UNITED STATES PATENT AND TRADEMARK OFFICE

| APPLICATION NO. | FILING DATE | FIRST NAMED INVENTOR | ATTORNEY DOCKET NO. | CONFIRMATION NO. |
|-----------------|-------------|----------------------|---------------------|------------------|
| 09/942,673 | 08/31/2001 | Eric Bouffard | P 283115 | 7804 |

Office Action Summary

Examiner
Bryan Fischmann

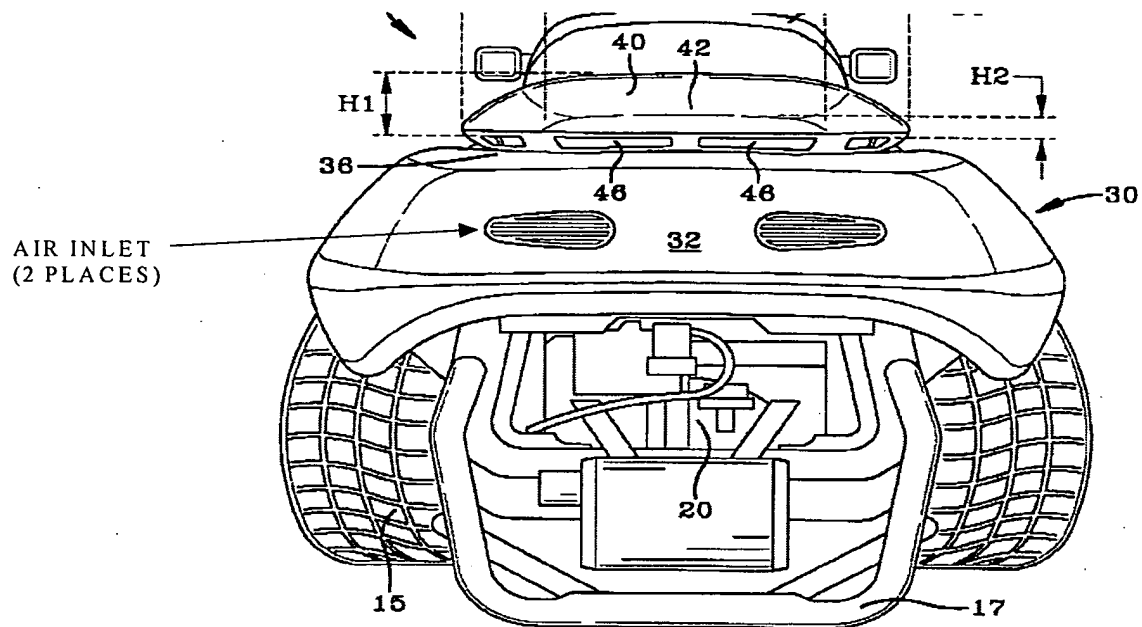
Further, note that Peter teaches an aperture (see following sketch) on the rear side of a rear fender (32). An aperture is advantageous on a rear fender in that it allows improved air flow to internal located components. Note that the aperture of Peter is proximal the air intake ("upstream" of 13) going to the carburetor (see English Language Abstract) of Japanese Patent 60-153418. Note also that the air intakes of Peter are above the rear wheels of Peter (Figure 3). This will improve airflow to the carburetor of Japanese Patent 60-153418. Japanese Patent 60-153418 does not explicitly mention an engine. However, the Examiner takes Official Notice that a carburetor is associated with an engine. The purpose of a carburetor is to provide correct the correct air/fuel ratio to an engine and to regulate the density of the air/fuel mixture to the engine by use of a throttle valve to regulate power output of the engine. This may be seen on many small tractors and mowers, as well as pre-mid 80's vintage automobiles.

Regarding claim 12, see Figure 3 of Peter and Figure 1 of Japanese Patent 60-153418.

Regarding claims 13 and 14, see reference number 43 of Japanese Patent 5-147565. Also regarding claim 14, note that the rearwardly facing apertures of Peter are positioned to avoid interaction with a water wave created in a front portion of the vehicle.
